AMENDED PLAN

PROPOSED CONVERSION OF
ANTIQUE CENTRE TO FLATS
AT THE CHAPEL EMPORIUM,
LONDON ROAD, LONG SUTTON
FOR

ELEVATIONS AS PROPOSED

1:100 SD07-005/3
MARCH-07 B.GILHAM.

ALTERATIONS TO RECENTLY INSTALLED NEW WINDOW

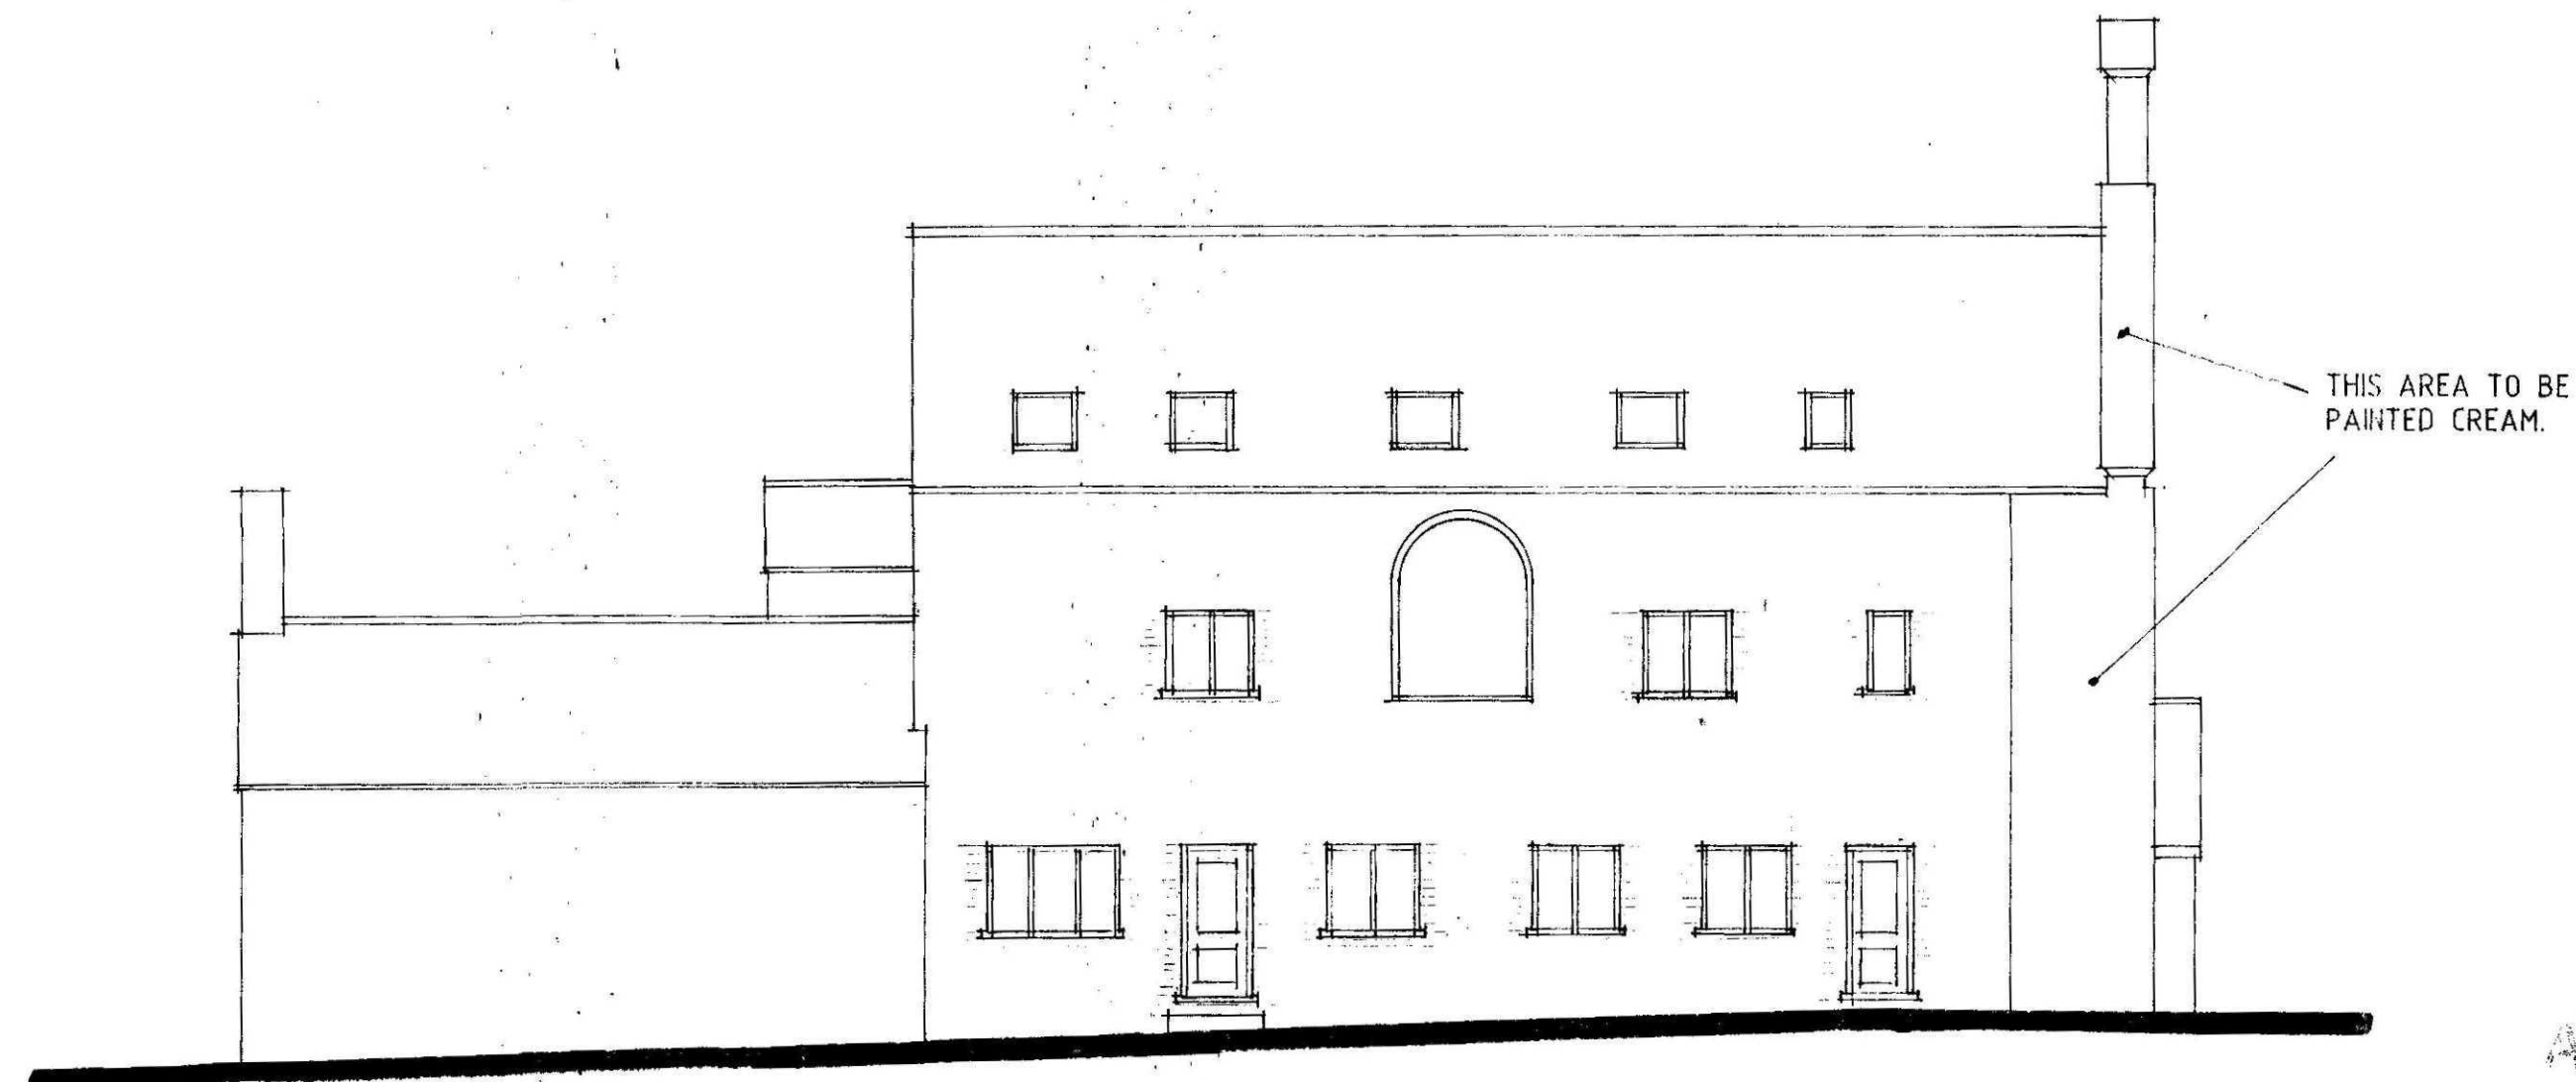
PROVIDE ADDITIONAL CENTRAL HORIZONTAL BAR WITH 2ND OPENING LIGHTS DIRECTLY ABOVE AS SHOWN HINGED FROM THE BOTTOM & OPENING INWARDS. ALL GLASS TO BE OBSCURED.
CILL OF WINDOW IS 1.0m ABOVE FIRST FLOOR LEVEL.
THIS RELATES ONLY TO THE WINDOW IN BEDROOM 1. TO FLAT 5. ON THE FIRST FLOOR
